I-66 and US 27 Interchange

Somerset, Kentucky

VALUE ENGINEERING STUDY
for the
Kentucky Transportation Cabinet

Final Report

Clifty Rd. Bridge Estimated Savings.

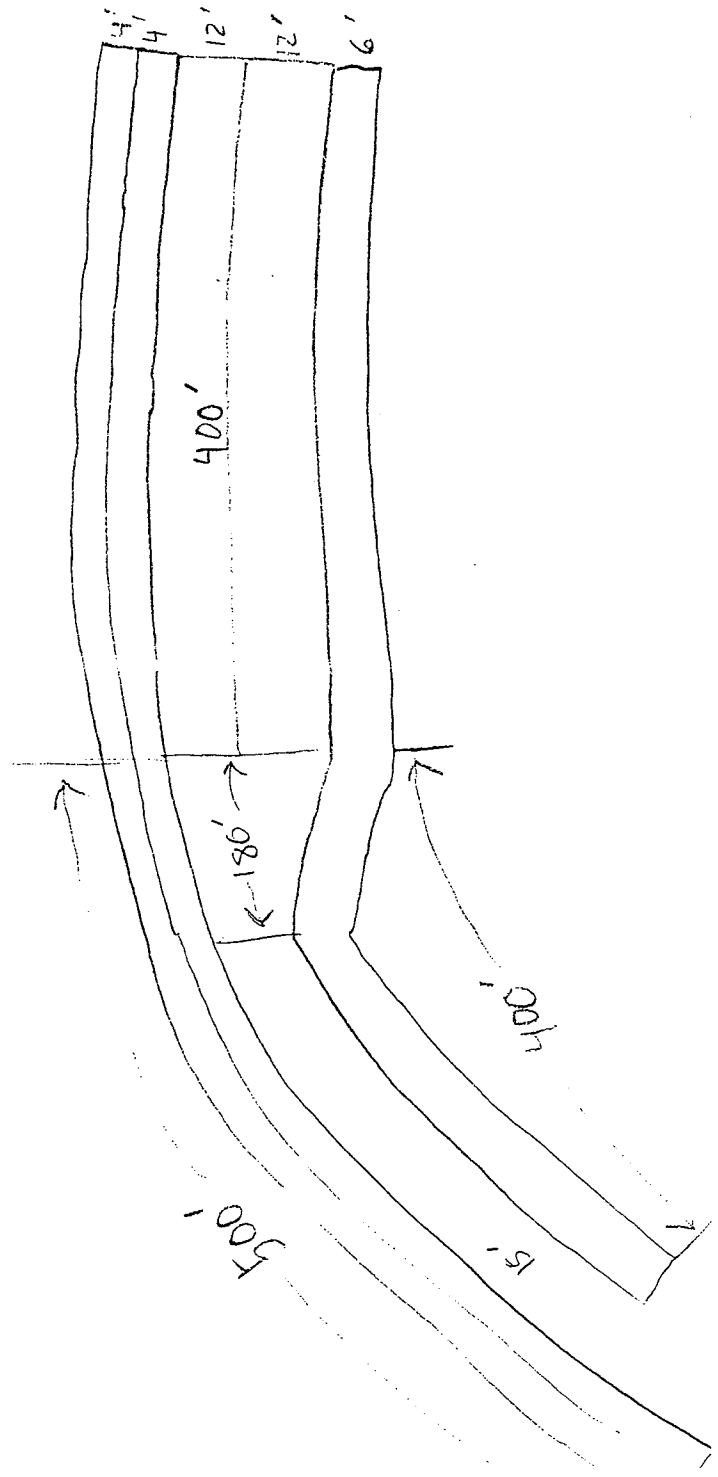
- By Eliminating ramp 5, the length of the Clifty rd. Bridge by 125'.

5000 sf reduction,

$$5000' \times \$55.50 = \$277,500$$
